**Condition 98****Welded or Sealed Pipes**

Subject: Pipe Material Technical Memorandum

**Subject:** Response to Comments and Questions on the Los Osos Wastewater Project

**Figure 1**  
**Los Osos Wastewater Collection System**

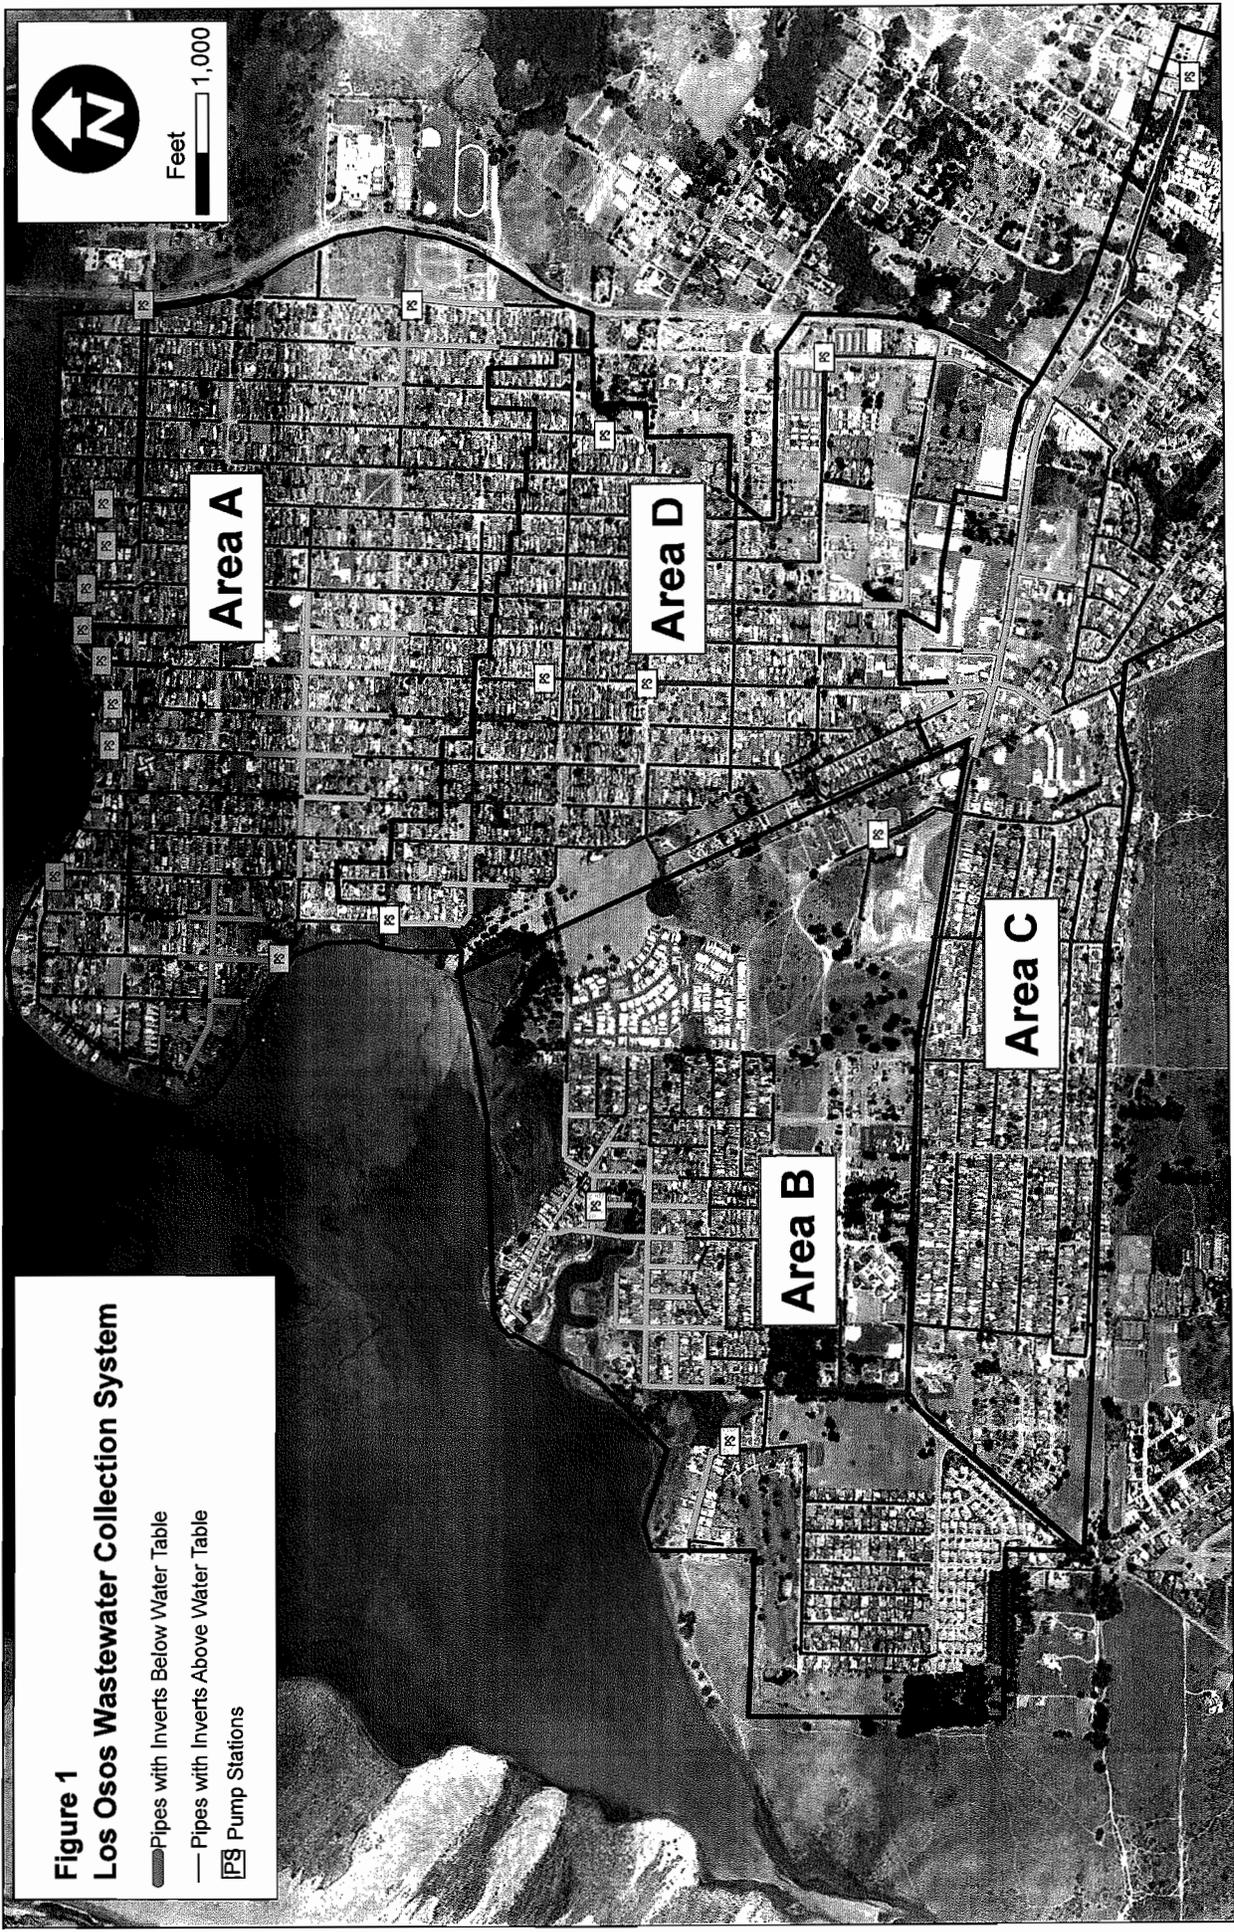
The general alignment of the sewer mains and the locations of the pump stations for the collection system are shown in Figure 1. The depth of the sewer mains ranges from 5 feet to 16 feet below grade. Areas where the sewer will be located below the groundwater are also shown in Figure 1 as red lines. The approach used to estimate areas where the depth of the as-designed sewer was below the estimated groundwater depth involved a digitized surface of the water table from groundwater contour data for the 1999 — 2003 time period. The depth of the groundwater was then compared to the proposed pipe invert elevation at each manhole. The result was that approximately 35,700 feet of pipe will be installed at or below the water table.

This correlates well with the high groundwater areas defined in the June 29, 2009 Planning Commission Memo. Pipes constructed below an elevation of 5 ft msl, which could potentially be impacted by future sea level rise, are shown as well as those pipes to be installed above an elevation of 5 ft msl but still below the water table.. The pipes installed below the water table identified in this figure are similar to the pipes identified in Figure 1.

Current standards for materials and installation practices provide for sealed joints with PVC sewer pipes. However, the combination of deep pipes and high ground water does raise constructability issues which could lead to a decrease in the quality of workmanship during construction if not properly managed and inspected. Additionally, the costs of future repairs in these areas, if needed, would be disproportionate to repairs elsewhere in the system. CDM would recommend fusion welded pipes in such areas. Specifically, near the Lupine Pump Station where portions of the collection system pipes are more than 13 feet deep with high groundwater.

CDM recommends AWWA C900/C905 PVC pipe in areas of high groundwater and that all joints and pipe sections be visually inspected for proper installation and joint integrity.

CDM recommends the use of AWWA C900/C905 pressure pipe as the most practical and economical solution to provide a sealed piping system in areas of high ground water.
